MINERALS PROGRAM INSPECTION REPORT
PHONE: (303) 866-3567

MINE NAME: Phil Sheridan Lode	MINE/PROSPECTING ID#: M-1988-081	MINERAL: Gold and silver	COUNTY: Boulder
INSPECTION TYPE: Monitoring	INSPECTOR(S): Amy Eschberger	INSP. DATE: September 16, 2021	INSP. TIME: 10:00
OPERATOR: Harry Covey	OPERATOR REPRESENTATIVE: Janice Wheeler, Dennis Covey	TYPE OF OPERATION: 110(1) - Hard Rock Limited Impact	
REASON FOR INSPECTION: Normal I&E Program	BOND CALCULATION TYPE: None	BOND AMOUNT: \$6,100.00	
DATE OF COMPLAINT: NA	POST INSP. CONTACTS: None	JOINT INSP. AGENCY: None	
WEATHER: Clear	INSPECTOR'S SIGNATURE: 	SIGNATURE DATE: September 24, 2021

This inspection of the Phil Sheridan Lode (Permit No. M-1988-081) was conducted by Amy Eschberger of the Division of Reclamation, Mining and Safety (Division) at the request of the operator's daughter Janice Wheeler, to discuss final reclamation of the site. The operator was represented by Ms. Wheeler and Dennis Covey during the inspection. The operator, Harry Covey, passed away in late June of this year. Ms. Wheeler is working with our office to provide the necessary documents demonstrating Mr. Covey is deceased, and that she is the executor of his es

M-1988-081 / Phil Sheridan Lode / Harry Covey / 110(1) Permit

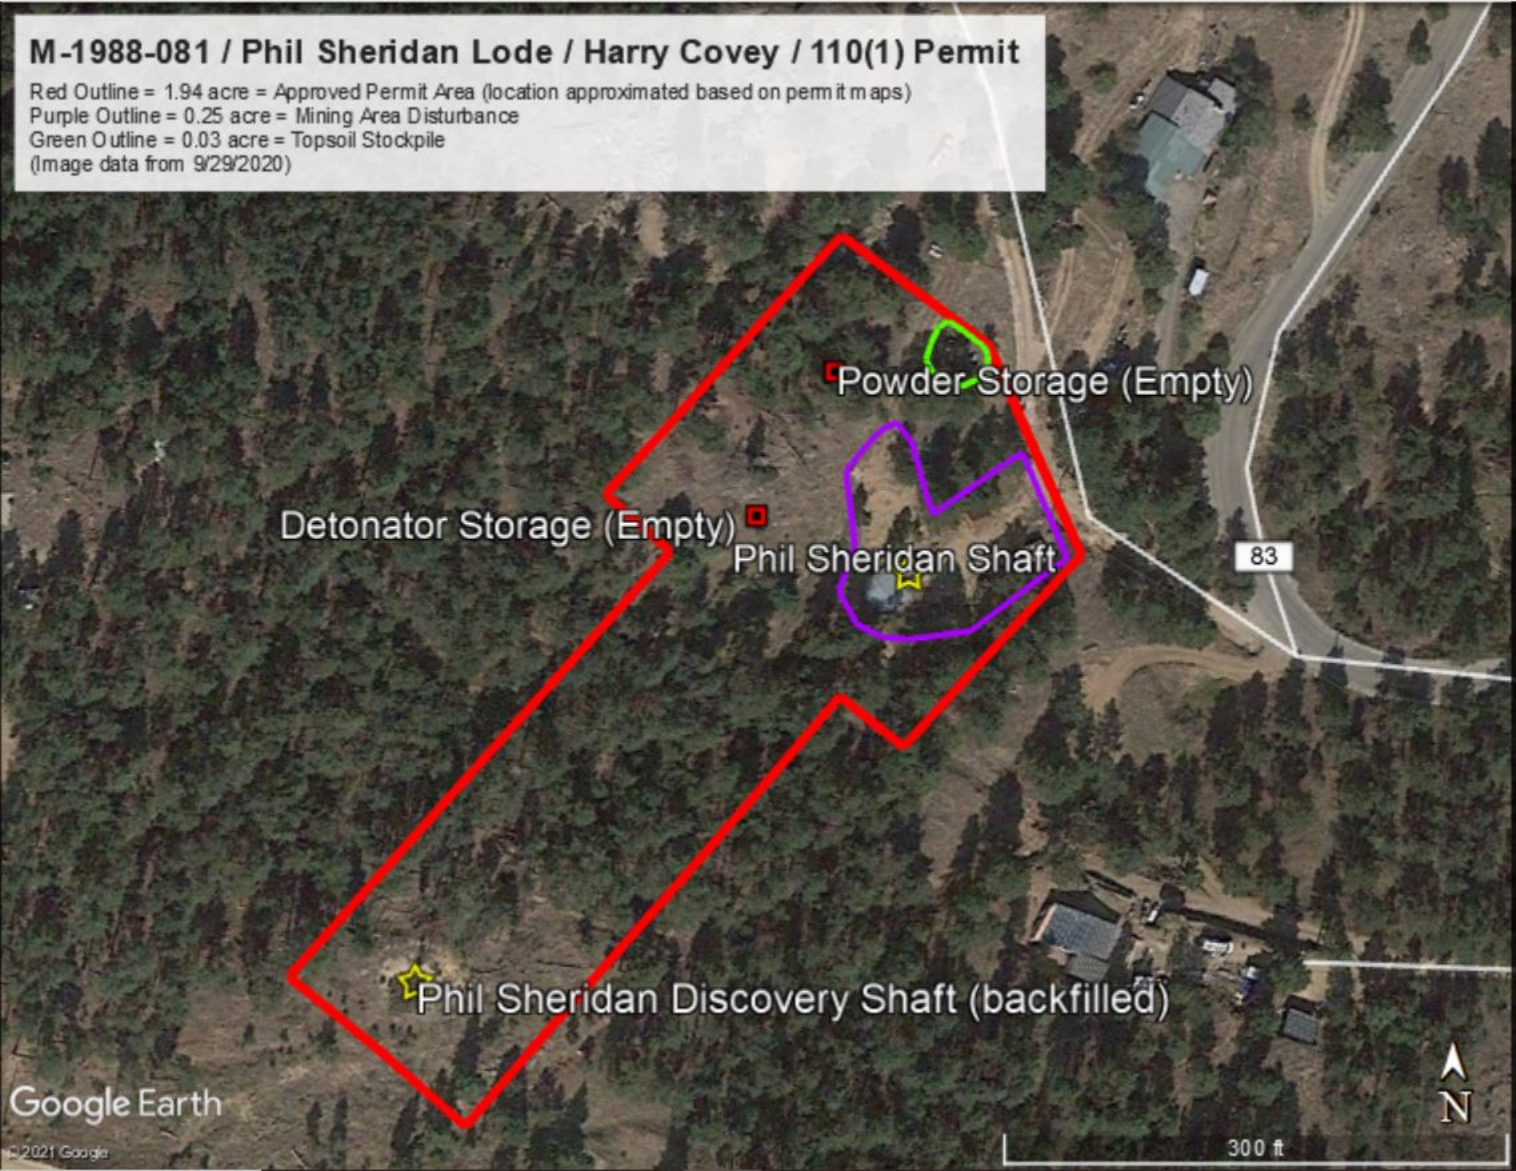
Red Outline = 1.94 acre = Approved Permit Area (location approximated based on permit maps)

Purple Outline = 0.25 acre = Mining Area Disturbance

Green Outline = 0.03 acre = Topsoil Stockpile
